Product Change Notification

Change Notification #: 113254 - 00
Change Title: Intel® Server System R1304GZ4GC
PCN 113254-00, Product Design
Update the System Rear Panel, Add a Mylar
and Plastic Block

Intel is implementing the following changes on the Intel® Server System R1304GZ4GC:

Figure One

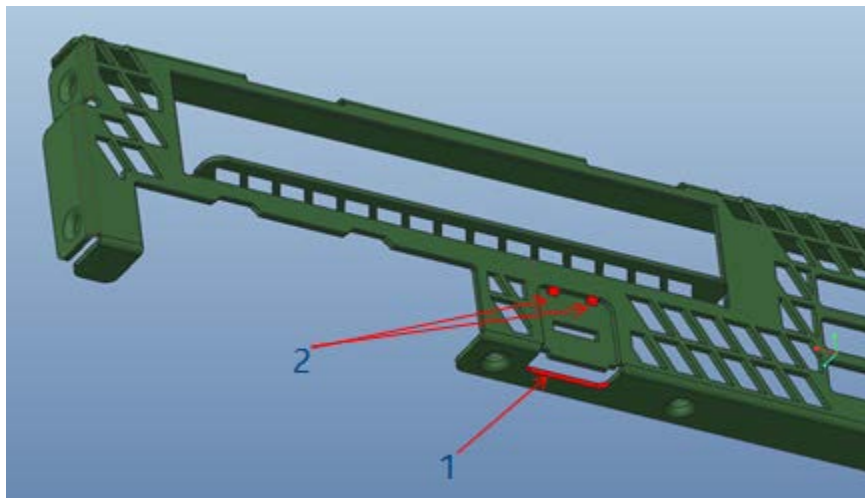
1. Add a connection at the bottom of the RMM4 (Remote Management Module 4) slot to improve structure strength. See item 1 in the Figure One.
2. Update the one big center joint to two smaller joints so that the joints will not conflict with the LAN cable connector latch. See item 2 in the Figure One.

Figure Three

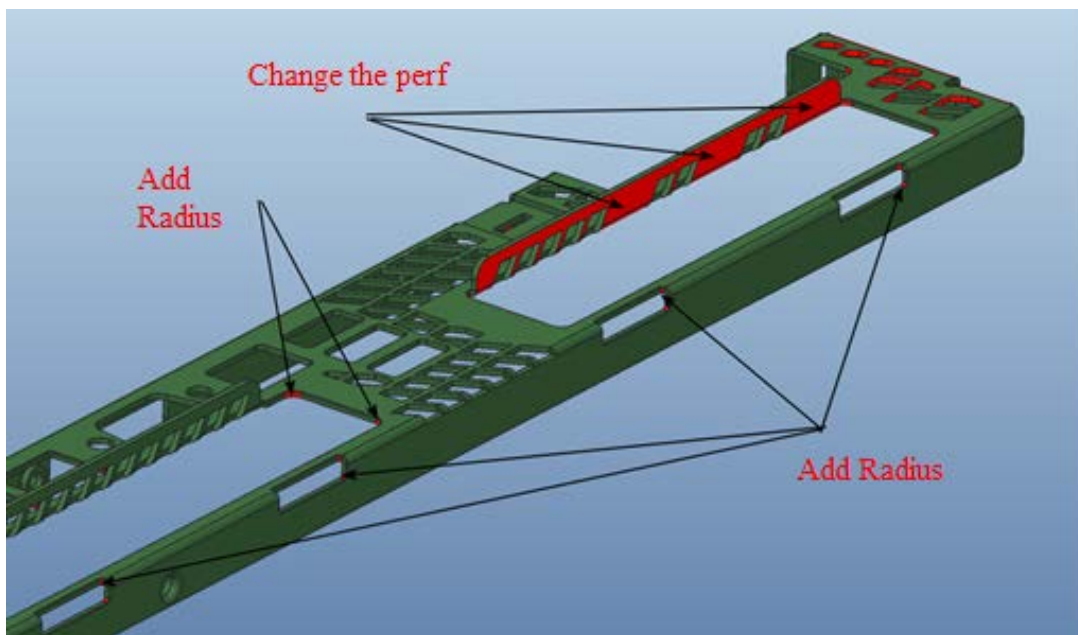
4. Update the perf and add radius to improve structure strength. See the Figure Three and Four.

Figure Five

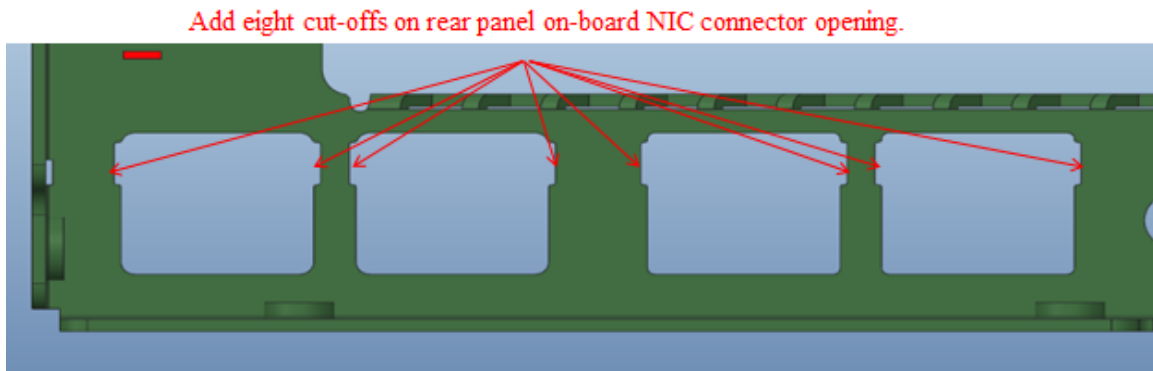
5. Add eight cut-offs around the on-board NIC (Network Interface Controller) openings to improve the LED visibility. See the Figure Five.

Figure Six

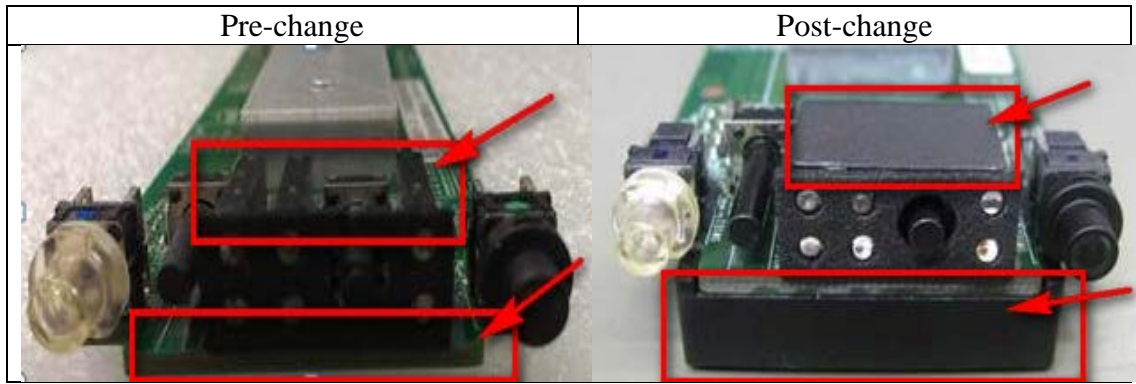
6. Add a mylar on the top of the front panel board and add a plastic block for the front end under the front panel board to hold parts more securely. See the Figure Six.
